Rezoning Transportation Analysis

Petition Number: #2022-111

General Location Identifier: 05508105, 05508104, 05508103, 05508113

Date	Description
11-28-22	First Review (PDM)
12-22-22	Second Review (DR)
01-25-23	Third Review (PDM)

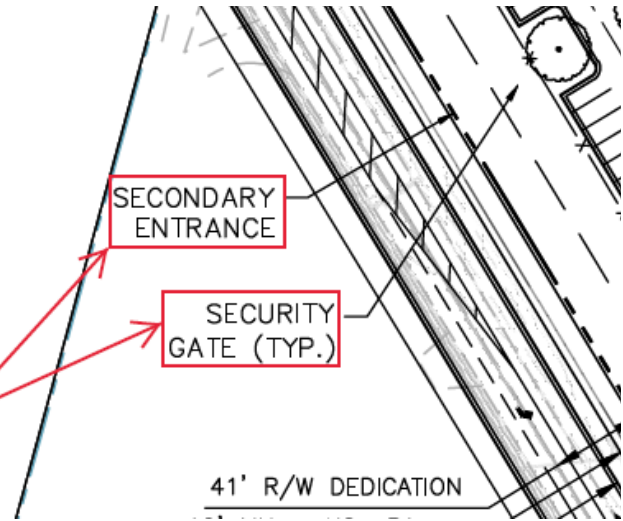
- 5. ~~Per coordination with NCDOT turn lanes will be required at the Rhyne Road proposed accesses. Confirm turn lane requirements with NCDOT or provide a three-lane cross-section on Rhyne Road across the entire property frontage.~~

DSG PROPERTIES, LLC
PARCEL: 05325113
DB: 32275 PG. 944
LAND USE: VACANT
EX. ZONING: I-1 (CD)
PENDING REZONING: 2021-284 (I-1 (CD))

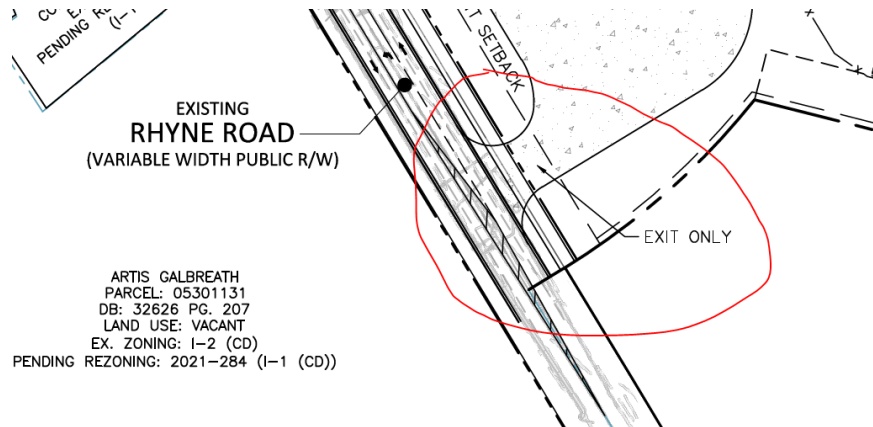
Remove callouts for security gate and secondary entrance. Don't look like they are needed here anymore.
